# UNITED STATES PATENT AND TRADEMARK OFFICE

10/549,305

<b>Office Action Summary</b>	<b>Application No.</b>	<b>Applicant(s)</b>	
	10/549,305	KUGE ET AL.	
	<b>Examiner</b>	<b>Art Unit</b>	
	Matt Benvenuti	4159

## **DETAILED ACTION**

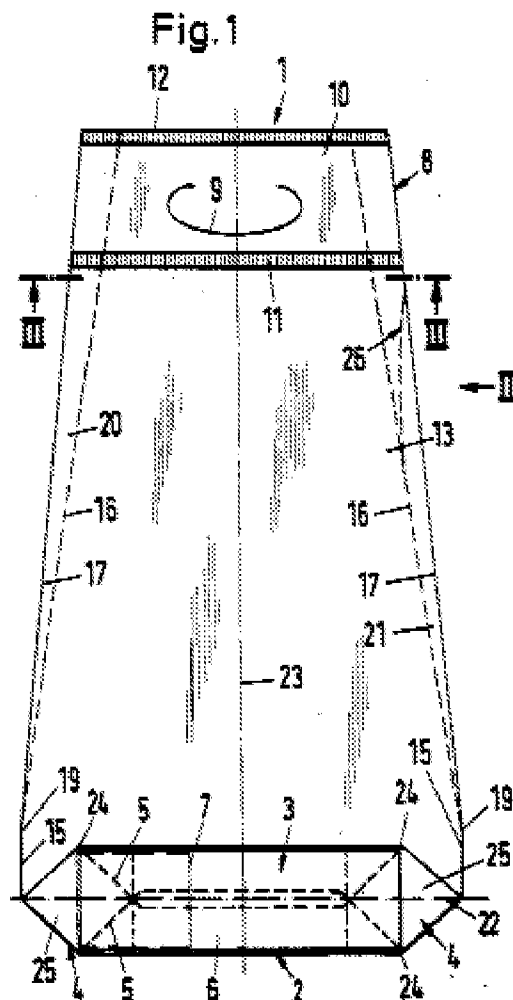
10. In re Claim 1, Bronstrup et al (Figure 1 shown above) teaches a fastener bag comprising:

**A pair of opposed flat surface portions (13, 14) and a pair of side surface portions (15, 16) disposed between both side edges of the flat surface portions (13, 14), the side surface portions (15,16) being folded inward (20, 21) so as to provide a gusset-type bag (1),**

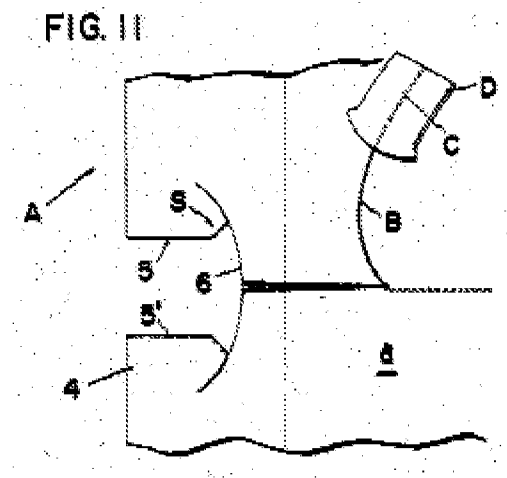
18. Tani (Figure 11 shown above) teaches a tear strip that extends the length of the bag side and includes a non-fused portion formed to the fused portion. It would have been obvious to one having ordinary skill in the art at the time the invention was made to extend both the fastener and the tear strip across the entire side portion of the bag, to create a bigger opening and allowing easier access to the bag contents, such that boundary portion between the fused portion and the non-fused portion surround the tab portion.
